Seismic Walkdown Checklist (SWC)

Diablo Canyon Power Plant, Unit 2

Licensing Basis Evaluation

Sheet 1/81

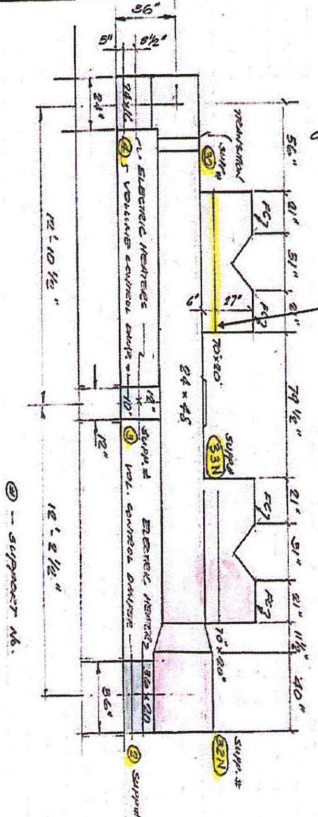
Motor Operated Damper DC-2-23-P-D-VAC-2-MOD-10 was modified by adding structural steel channel stiffeners (approximately 19# per linear foot) on the top and bottom of the damper. The channel sections also extend to and stiffen the damper immediately adjacent to MOD-10 (DC-2-23-P-D-VAC-2-MOD-10A). Reference PG&E Drawing 59353 for a layout of the dampers. The concern is that the heavy channel stiffeners may adversely impact the seismic qualification of the ducting/duct supports associated with the MOD Dampers.

A review of the seismic calculation for the ducting/duct supports associated with the MOD Dampers (Calculation HV-86, Revision 0) shows that the additional mass from the channel sections was not considered in the qualification of the ducting/duct supports. A copy of this calculation has been revised (marked up) such that it now accounts for this extra mass. This markup is found under sheets 2 thru 18. The mark up demonstrates that the ducting/duct supports would remain seismically qualified (with significant margin) if the additional mass from the channel stiffeners is considered.

HVAC Duct Support Nos. 30 and 33N are impacted due to unaccounted weight of Duct stiffeners. (70"x20").

Equipment No. DC-2-36-E-PNL-RNARA

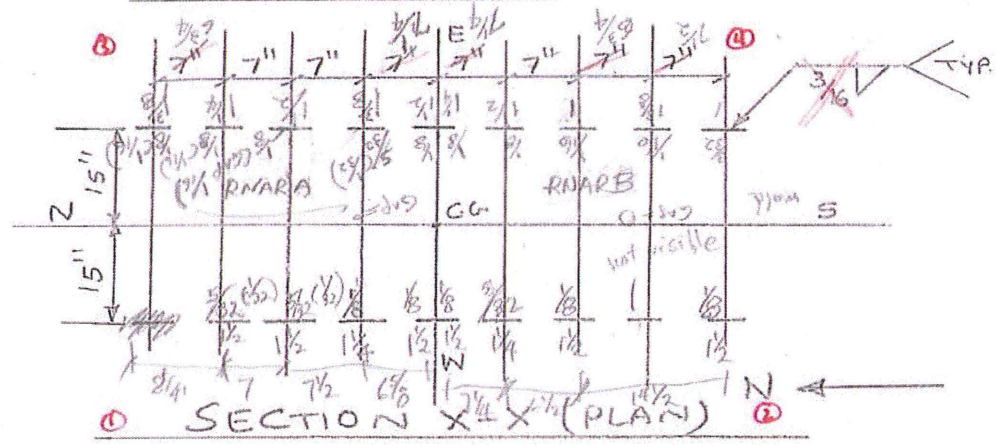
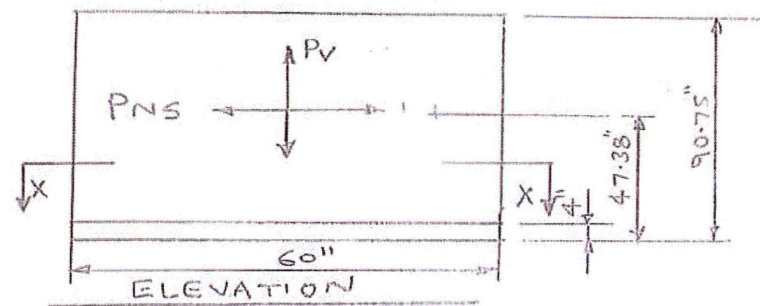
5. Is the anchorage configuration consistent with plant documentation? (Note: This question only applies if the item is one of the 50% for which an anchorage configuration verification is required.) N/A
The welds appear to be shorter and smaller than that specified as the original welds on drawing 050053-64.

ASSUME BOTH CABINETS AS ONE UNIT FOR ANALYSIS.
 WEIGHT OF ONE CABINET = 1200 LBS (AS-BUILT 1340 SEE SAT. 10 FOR REV.)
 TOTAL WEIGHT OF SYSTEM = 2 x 1.2 K x 1.1 = 2.64 K
 $\therefore PV = 2.2 \times 2.95 = 5.81 K$

CONCLUSION: EXISTING WELDS ARE OK. NO MODIFICATION IS REQUIRED.

Equipment No. DC-2-65-E-UPS-IY21

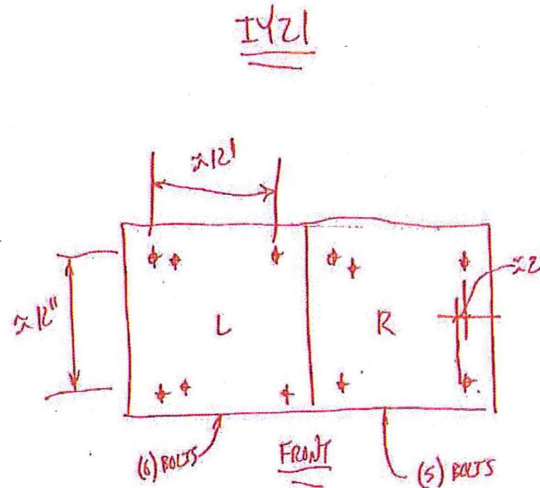
According to manufacturer, Ametek Solidstate Controls,

Seismic Accelerations: 5% damping floor peak RRS (see ES-68-1, Sheet 38)

The anchorage is consistent with calculation ES-68-1 Attachment 6, Sheet 21 (Anchorage option C).
